CHANGE ORDER

CO-001 · Crow & Timber · Nevada Library Countertop Adjustment

Nevada Library — Countertop Adjustment, Revised Scope, Change Order CO-001t

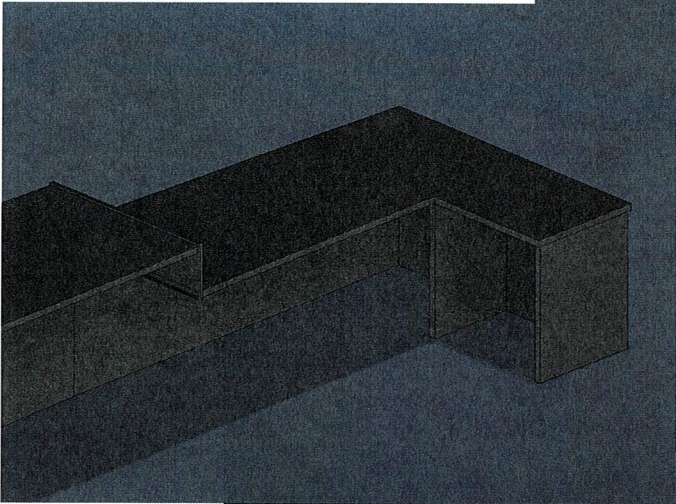
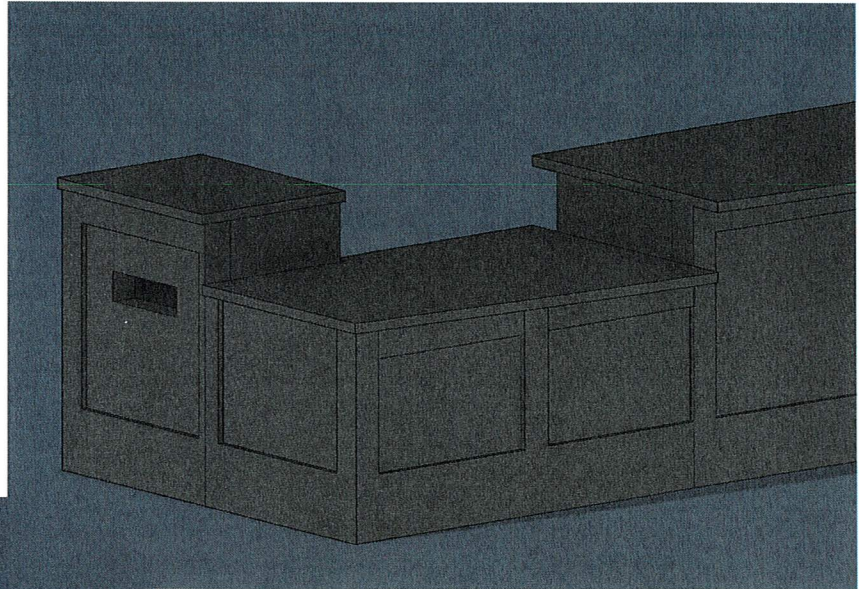
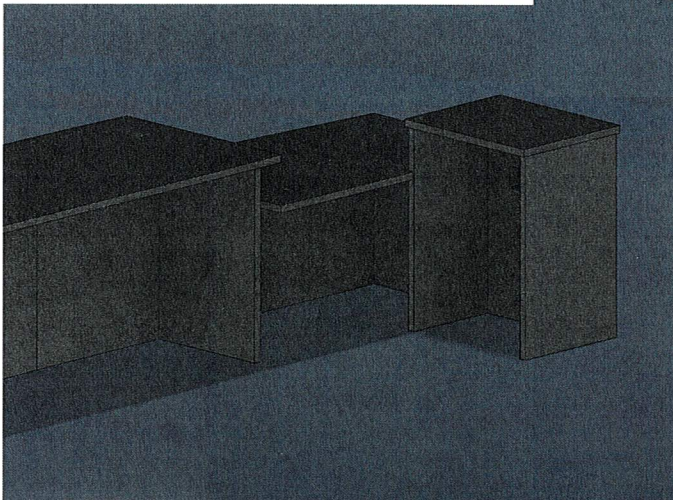
The scope has been expanded to include the 92.5" L-shaped corner section of the reception desk. All work described in the original scope applies to the revised area, including height reduction to 32", support structure modification, and finish matching throughout. Scope also includes relocation of the existing drop box and modification of the bookshelf unit beneath the counter to align with the revised counter height.

Revised section dimensions: Primary run: 91" long x 41" deep · Return leg: 66" long x 24" deep

The following views reflect the updated scope of work, showing the full L-shaped counter section lowered to an ADA-compliant height of 32". All dimensions and details are as described in the accompanying change order.
